GOVERNMENT OF MADRAS.

PUBLIC WORKS DEPARTMENT.

ORDER—dated 1st July 1889, No. 1737 W., Public Works.

*Madras Harbour: reconstruction works
and position of the entrance.*

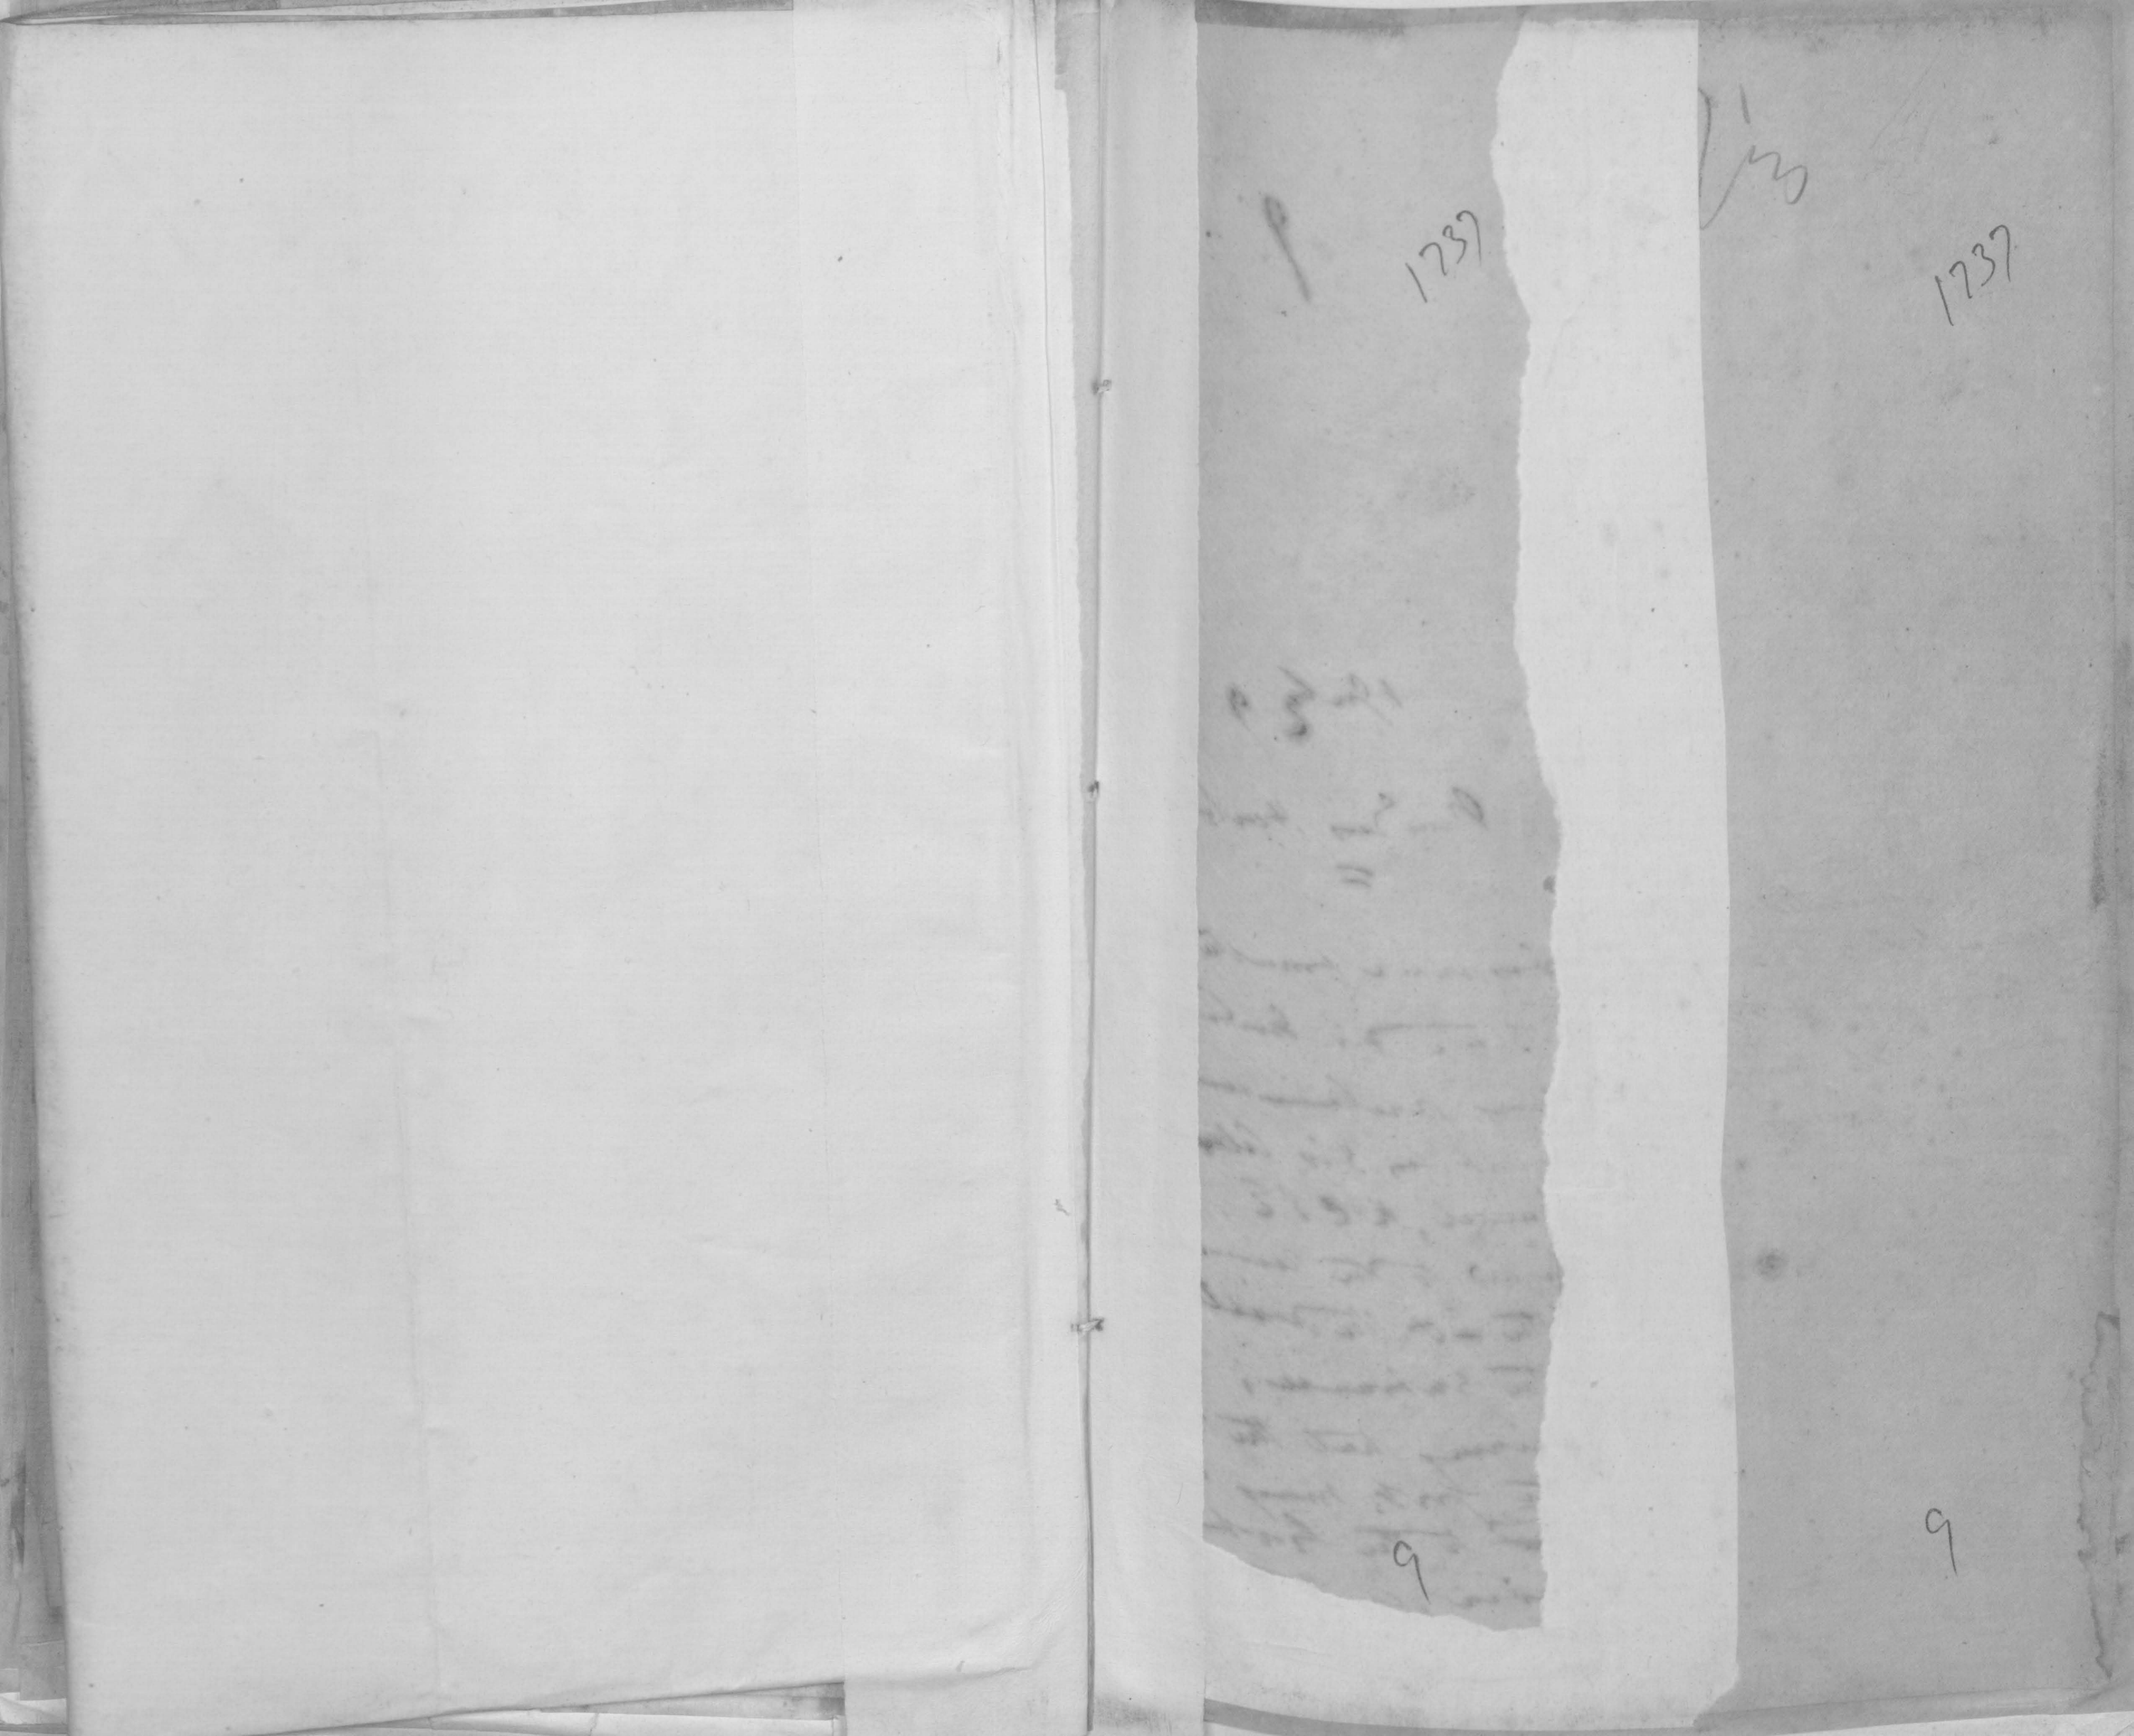
The type of harbour to which Madras belongs is very much that of Whitehaven, a copy of the chart of which I append to this report. Many years ago I was Consulting Engineer to this harbour, and I know it well. We have here an outer harbour, forming an approach, and nothing but an approach, to two inner harbours, each so enclosed by quays that ships lie undisturbed within them, with a space between them opening directly on to the outer harbour, and forming a beaching ground for ships and waves. It would be easy to devise a similar scheme for Madras, which would give it, say, 60 acres of enclosed dock (gates of course are not required), 9,000 feet lineal of wharfage, and 40 acres of quay space, enough to make it a first class port for a very large trade. Or, if it be preferred, the adjacent shores outside the harbour might be utilised for the purpose, and of course a combination of both ideas is possible. I claim no priority in suggesting either plan. Mr. Parkes has I believe roughed out the latter idea, Mr. Thorowgood the former, quite independently of me. But I may say, as a corroboration of their views more than anything else, that the first of the two schemes I have now suggested I broached when the harbour was first proposed; and I may add that, if it be adopted, the entrance might be kept at the width originally given to it of 500 feet which is by no means more than it should be.
